Greenland Consulting, Inc.

P.P.N. 7A-17A-001
Leroy Twp. ~ Lake County ~ Ohio

Septic System
Plan

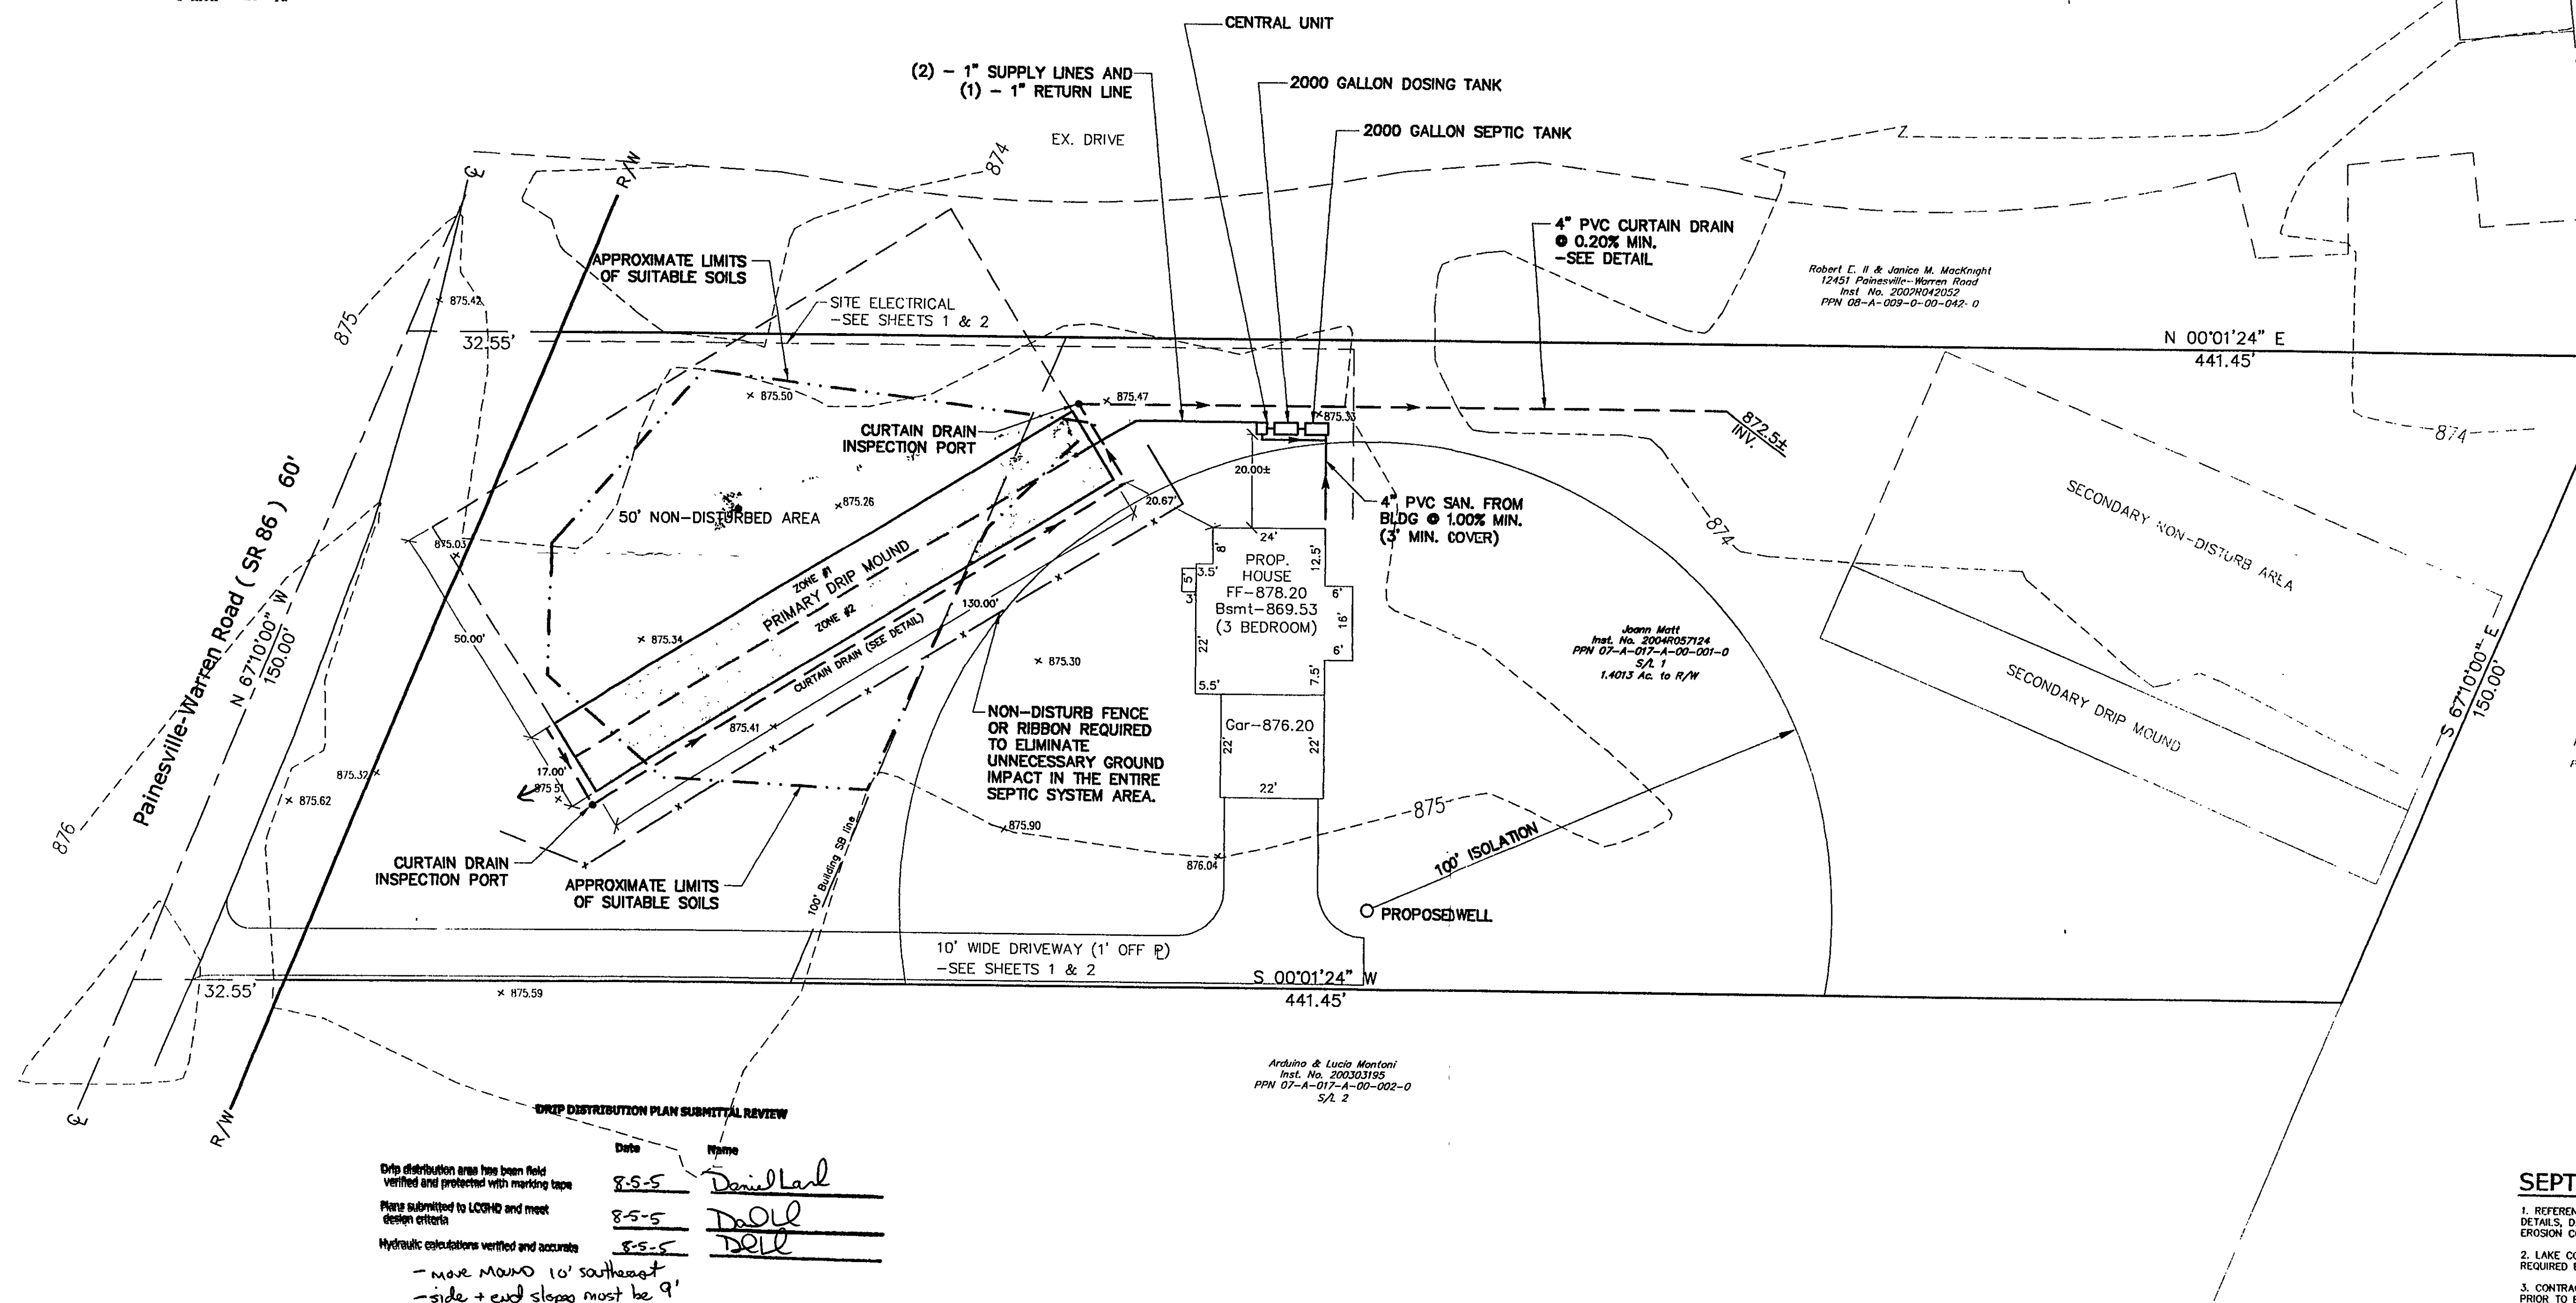
Drp distribution area has been field verified and protected with marking tape
Plans submitted to LCHD and meet design criteria
Hydraulic calculations verified and accurate
- move mound 10' southeast
- side + end slopes must be 9'
